MEMORANDUM

SUBJECT: **SILVER SPUR PEDESTRIAN PATHWAY PROJECT DESIGN**

SIGNING AND STRIPING CONCEPTS

ALTERNATIVE A

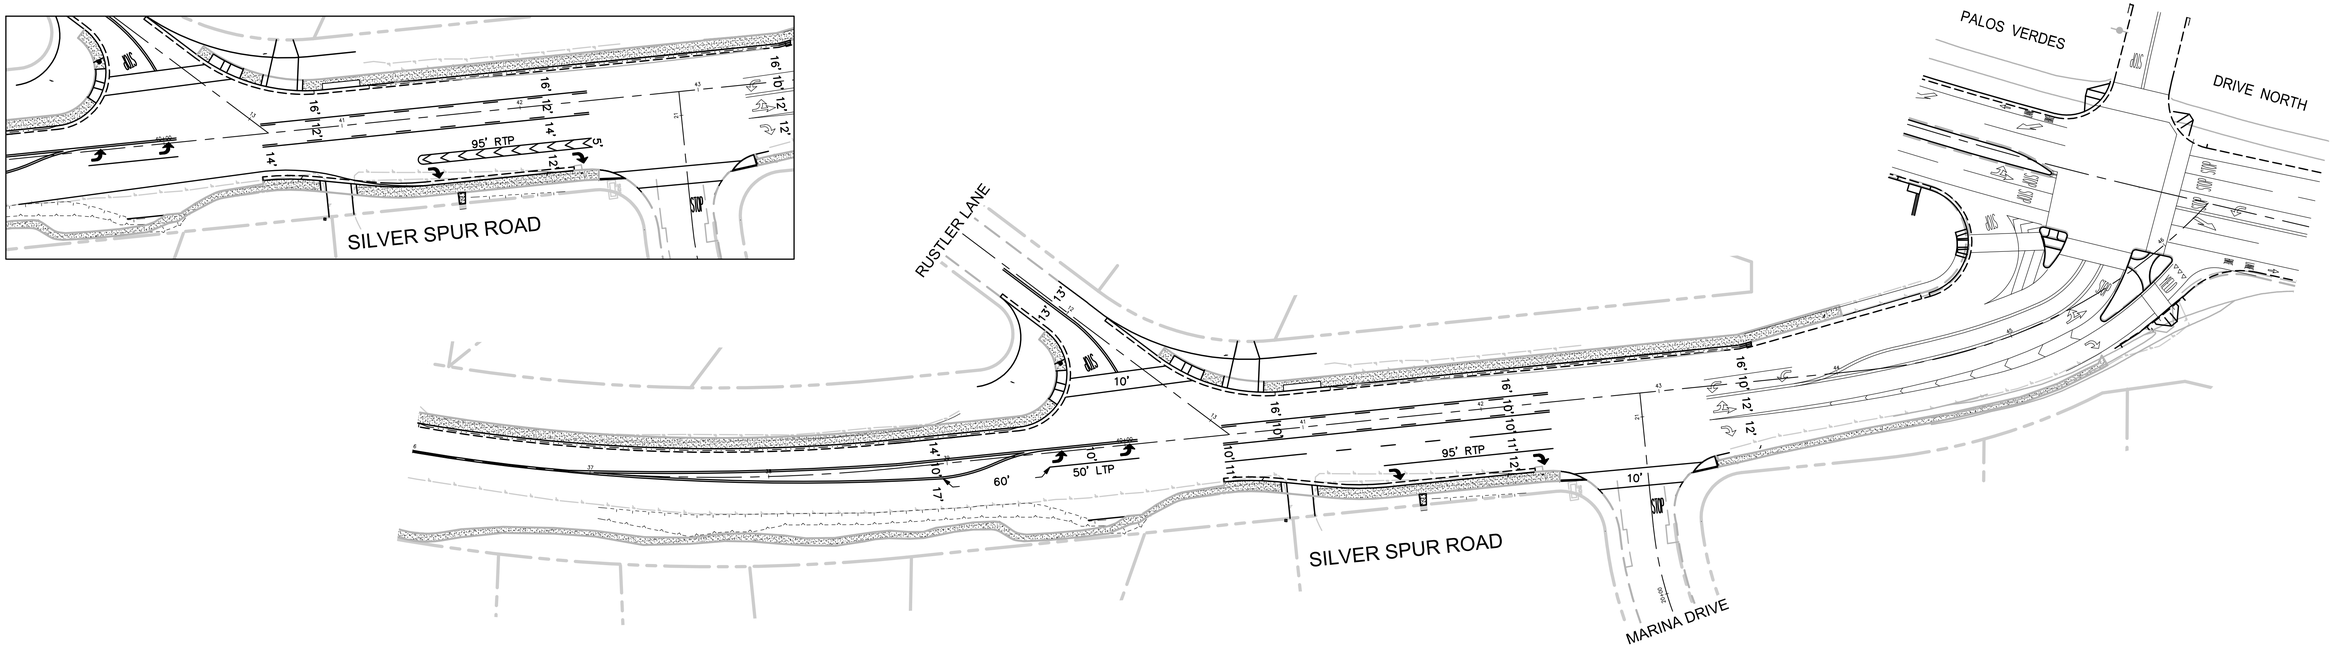
Alternative A was previously presented for consideration, which provides an eastbound right turn lane into Marina Drive, two eastbound through lanes, a two-way left turn lane, a westbound through lane and a westbound left turn lane into Marina Drive.

At the last Traffic and Safety Committee meeting, a few residents indicated that the addition of a second eastbound through lane was a concern. The estimated traffic volume on Silver Spur Road is ~14,500 vehicles per day split about evenly in each direction. The two eastbound lanes would not significantly impact the amount of traffic traveling on Silver Spur Road.

We have included an "inset" for each Alternative designed with one eastbound lane on Silver Spur Road at Marina Drive.

ALTERNATIVE B

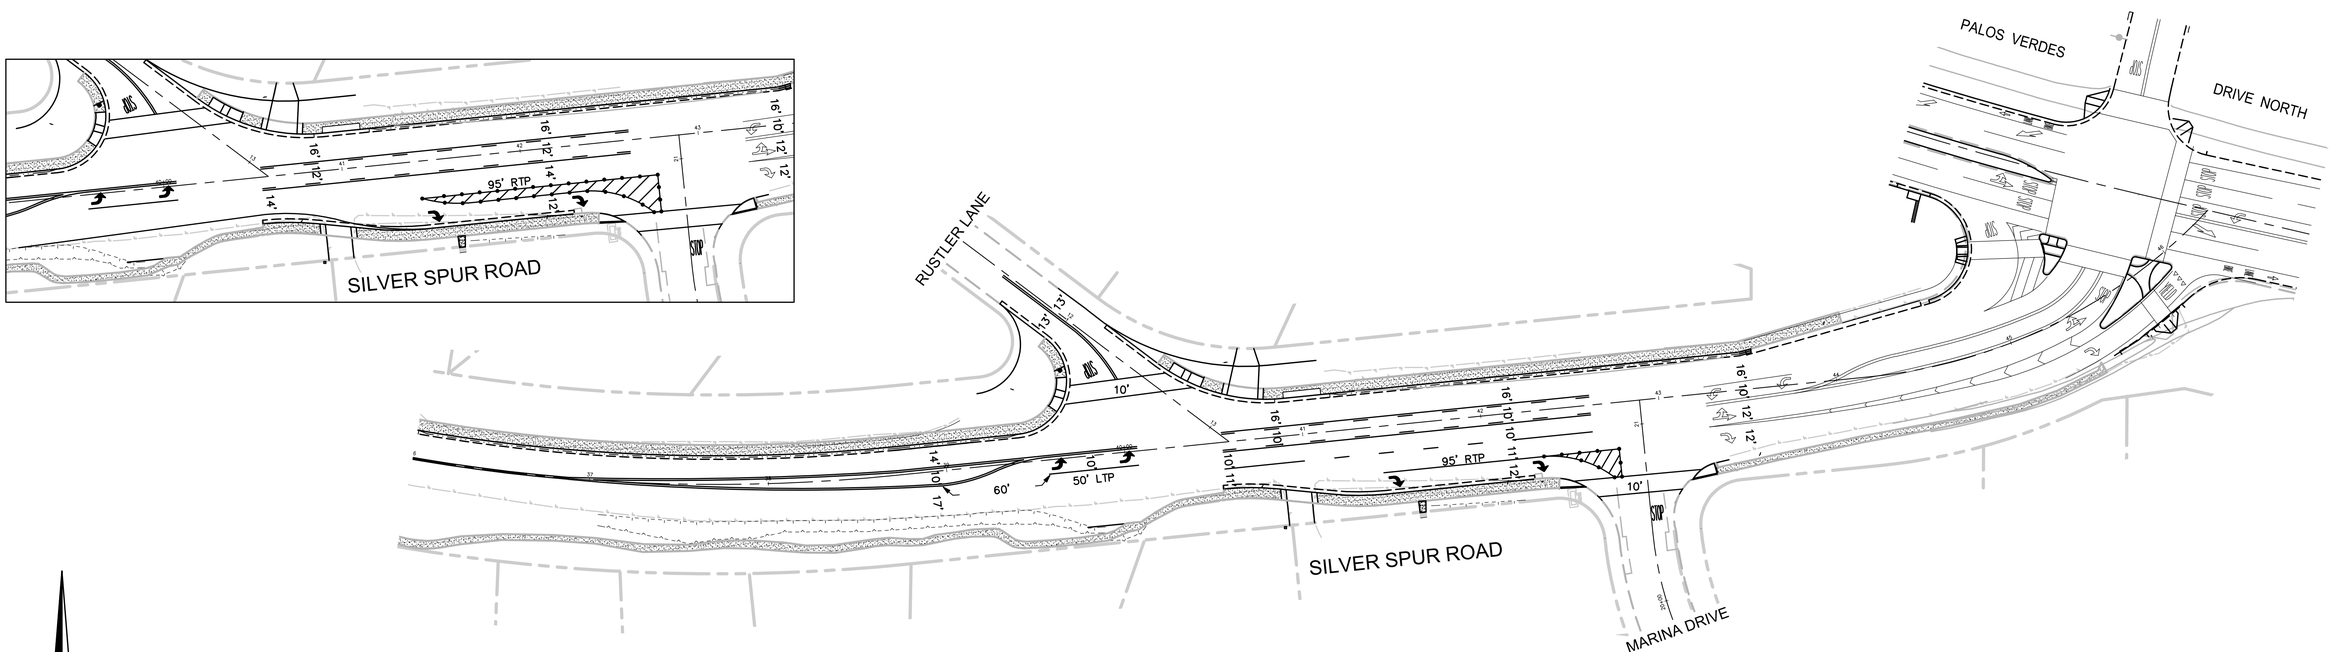
Alternative B would add a painted "island" to the eastbound Silver Spur Road right turn only lane at Marina Drive. Residents indicated that some motorists currently use the right turn only lane as a through/right lane and travel directly to Palos Verdes Drive North. This Alternative would prohibit motorists from traveling through the right turn only lane.

The painted island could be supplemented with flexible delineators or large raised pavement markers for additional visibility. The use of the flexible delineators (candlesticks) or large raised pavement markers would serve as visual reminders to motorists of the right turn restriction at Marina Drive. The flexible delineators are more visible because of their height. The large raised pavement markers, however, provide the same hindrance to vehicles and motorists.

ALTERNATIVE C

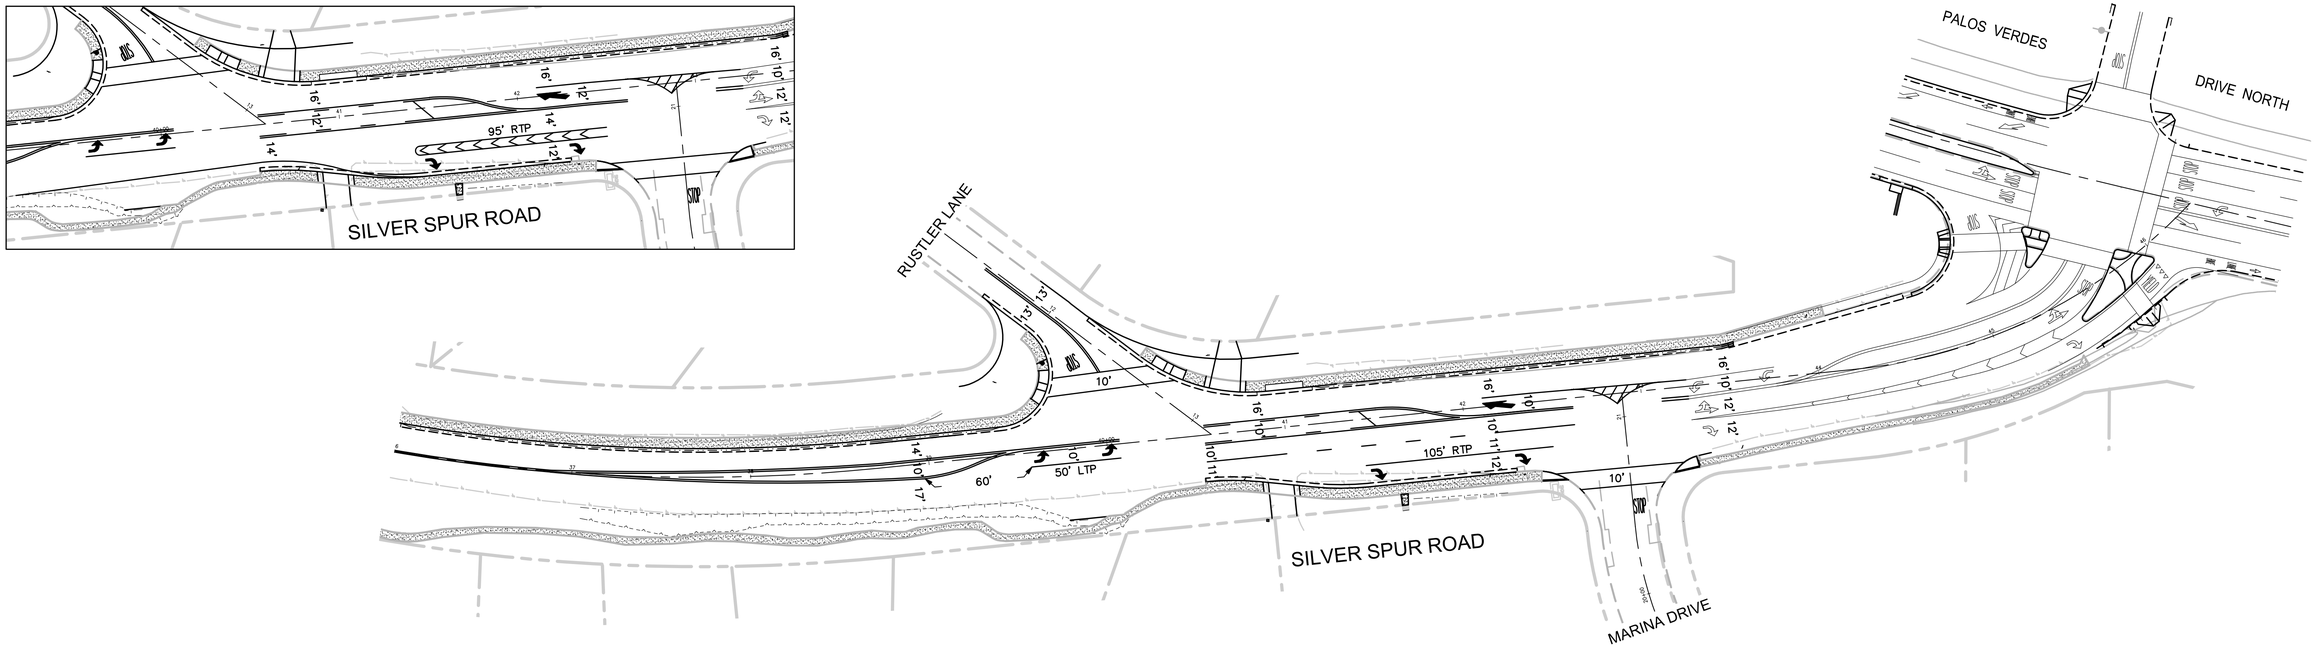
Alternative C provides additional traffic striping control for left turn movements into and out of Marina Dive. This Alternative creates a painted island in the center of the intersection to help direct left turning vehicles.

For vehicles turning left from Marina Drive onto Silver Spur Road, the painted island provides a storage area/acceleration lane on Silver Spur Road for these vehicles to merge into westbound traffic. This is similar to a two-way left turn lane but it removes/minimizes conflicts with other vehicles traveling in the opposite direction as is sometimes experienced in two-way left turn lanes.

For vehicles turning left from Silver Spur Road into Marina Drive, the painted island assists motorists by directing them on where their left turn should be executed. The painted island should minimize vehicles traveling too far west to turn into Marina Drive or "cutting the turn too short" and conflicting with vehicles coming out of Marina Drive.

ALTERNATIVE D

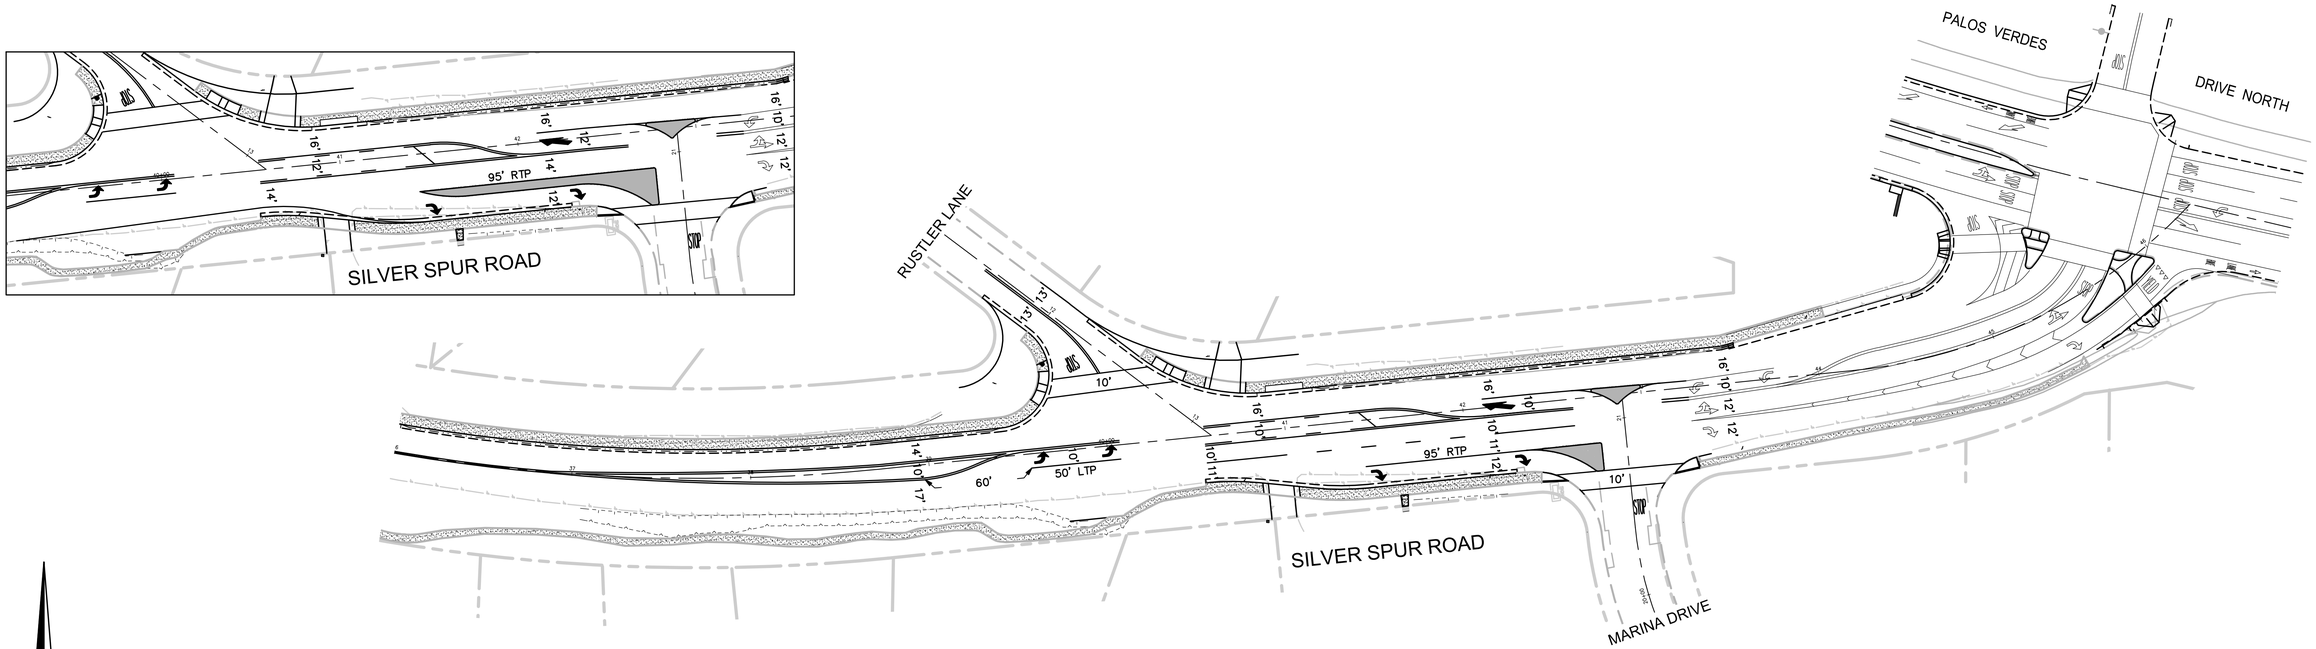
Alternative D is a combination of Alternatives B and C and is shown as raised median islands. This Alternative could also be painted islands. The size of the raised median islands may be able to accommodate some landscaping. However, the island in the center of the intersection would be restricted to very low growing vegetation to provide a clear line of sight for oncoming traffic.
